Access Compliance Report

Public Rights-of-Way

(Curb Ramps)

Intersection ID: 10019272	Main Street: 3RD-4TH_CONNECTOR_ST	Cross Street: N/A	Location: E
ADA ID: 561A227F0777	Ramp Type: BlendTrans1	Initial Pass/Fail: Fail	Overall Compliance: No
Severity Score: 33.75			
Codes/Mitigation Info/Possible Solution		Field Measurements/Component Compliance

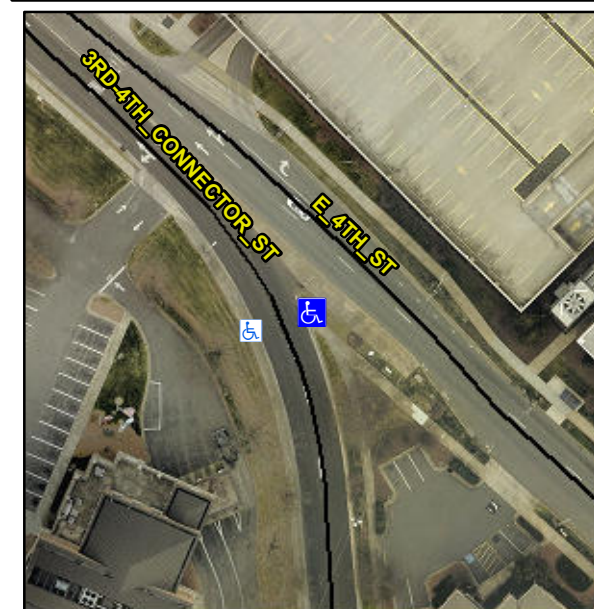
R304.5.1, R304.5.3

Compliance	Description	Data	Compliance	Description	Data
N/A	Ramp Length (in)	43.0	Yes	BlendTrans Slope (%)	2.2
No	Ramp Width (in)	43.0	No	BlendTrans XSlope (%)	10.9
N/A	Flare Type LT	N/A	N/A	Flare Type RT	N/A
N/A	Flare Slope LT (%)	N/A	N/A	Flare Slope RT (%)	N/A
N/A	Flare Traversable LT?	N/A	N/A	Flare Traversable RT?	N/A
N/A	Landing Length (in)	N/A	N/A	DWS Provided?	N/A
N/A	Landing Width (in)	N/A	N/A	DWS Contrast?	N/A
N/A	Landing Slope (%)	N/A	N/A	DWS Length (in)	N/A
N/A	Landing X Slope (%)	N/A	N/A	DWS Full Width?	N/A
N/A	Landing Curb? (Y/N)	N/A	N/A	DWS Offset (in)	N/A
N/A	Shared Landing?	N/A			
N/A	Gutter Ponding?	N/A	N/A	Gutter Slope (%)	N/A
N/A	Gutter Lip Ht (in)	N/A	N/A	Gutter X Slope (%)	N/A
N/A	Painted X Walk1?	No	N/A	Painted X Walk2?	N/A
	X Walk 1 Direction	To W		X Walk 2 Direction	N/A
	X Walk 1 Width (in)	N/A		X Walk 2 Width (in)	N/A
	X Walk 1 Slope (%)	0.5		X Walk 2 Slope (%)	N/A
	X Walk 1 X Slope (%)	7.7		X Walk 2 X Slope (%)	N/A

Remove & Replace Curb Ramp With Two New Directional Ramps or Equivalent.
